BID ADDENDUM No. 2

Re: Florida Union Free School District
District Wide Capital Improvements (Bond Phase II)
SED No.: 44-21-15-02-0-004-013
SED No.: 44-21-15-02-0-001-015
SED No.: 44-21-15-02-0-003-010
BBS File No. 20-176a-c

2. Drawing E0.01b – Electrical Notes and Legends:
 - a. Construction Drawing is hereby deleted and replaced with the attached.
3. Drawing E1.02b – Electrical/Mechanical Demolition Plans:
 - a. Construction Drawing is hereby deleted and replaced with the attached.
4. Drawing E4.01b – Electrical Proposed Power Plans:
 - a. Construction Drawing is hereby deleted and replaced with the attached.

5 RTU PROPOSED POWER PLAN

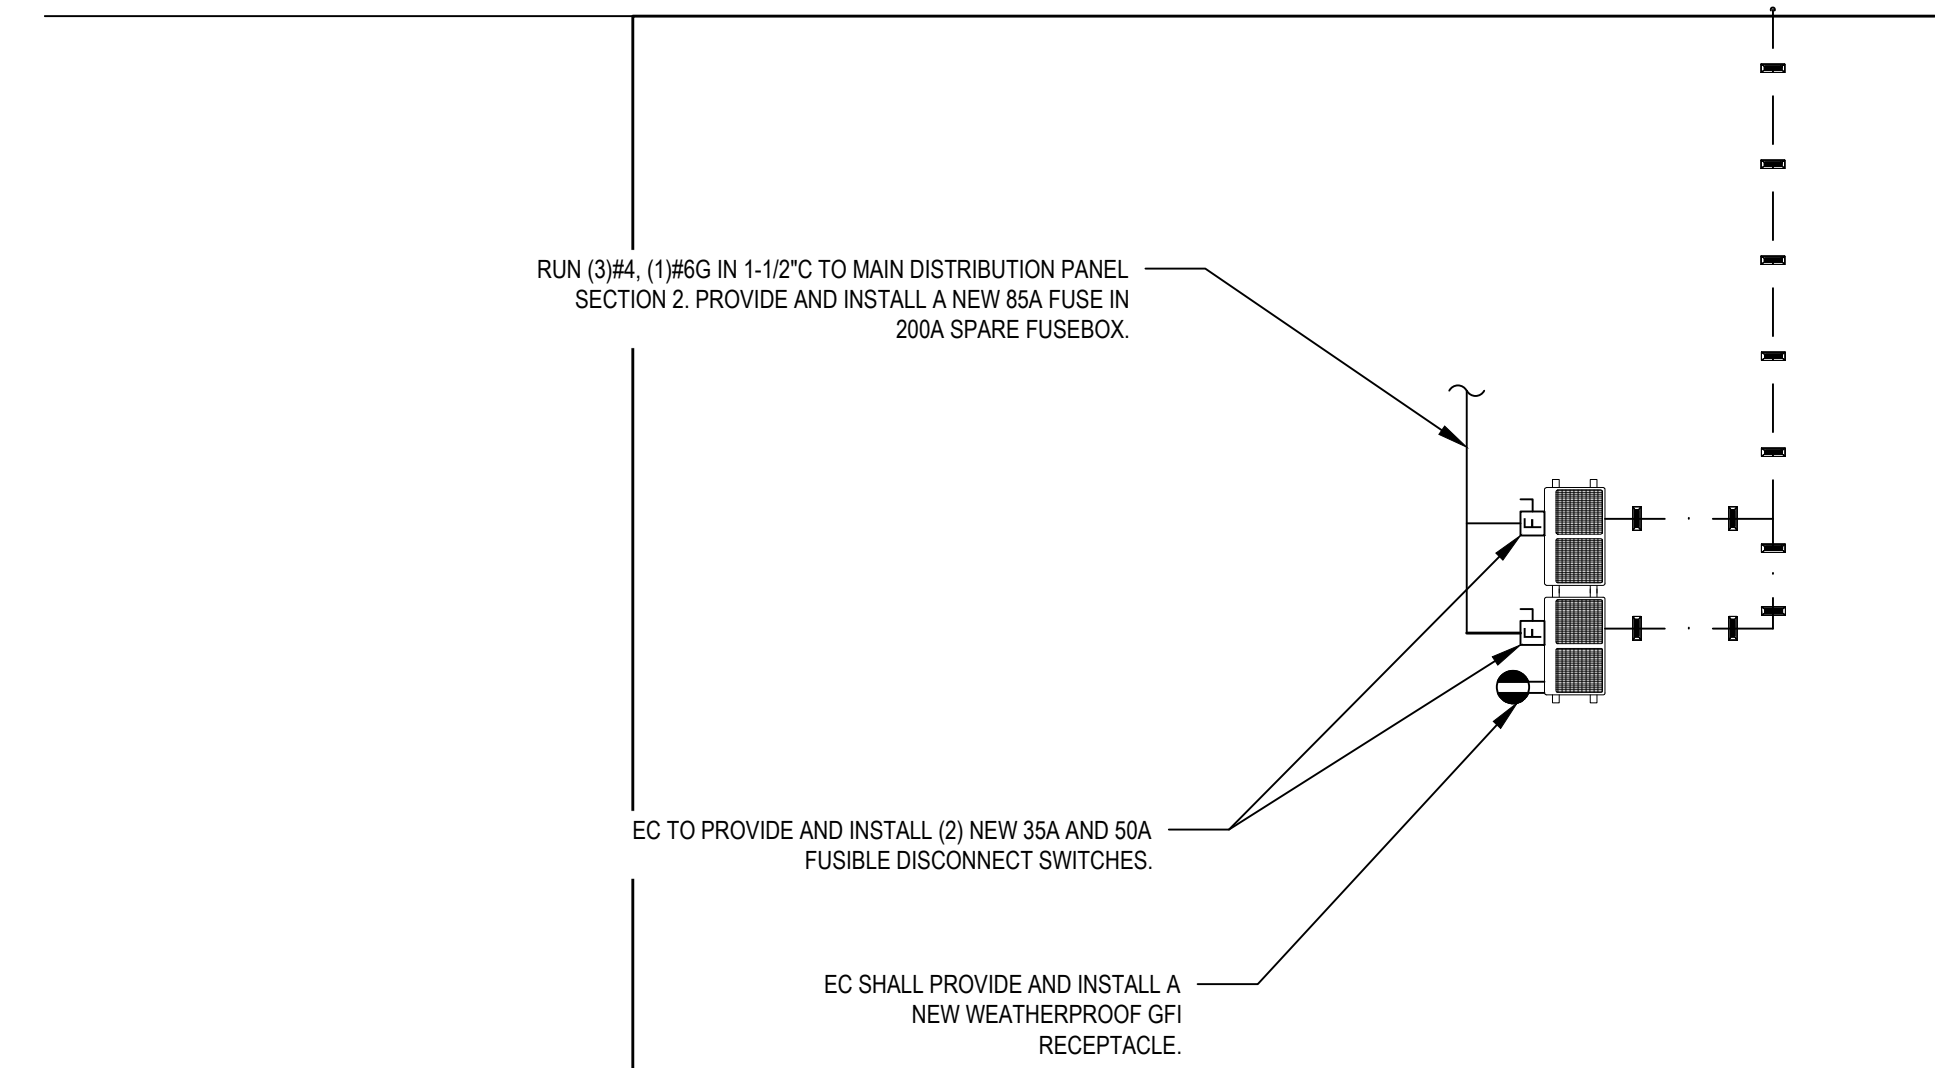
1. *Who is responsible for the site work (excavation restoration) for the light poles – The Electrical Contractor or Site Contractor?*
2. *Smoke detectors with the symbol E, R, RR, RL next to them – Are they new?*
3. *Who is providing the lighting controls – The Owner or the Electrical Contractor?*
4. *For the new recessed wall boxes, please show where the data cables are being terminated (IT Racks)?*
5. *Dwg. E4.01b, Detail 5 - Where is this RTU located?*

1. Refer to Dwg. E2.01a, the Electrical Contractor shall trench and backfill (including compaction) for the placement of new conduit.
2. Refer to Dwg. E1.01b, the description for the device symbols is identified in the boxed notes adjacent to the Demolition Devices Legend.
3. All new lighting controls shall be provided and installed by the Electrical Contractor.
4. Data cables shall be terminated to IDF 3 located in Second Floor Storage Rm. 009. Refer to Construction Drawing Modifications herein for additional information.
5. Mechanical equipment is located on the roof above the second floor classrooms above the boiler room shown in Detail 4.
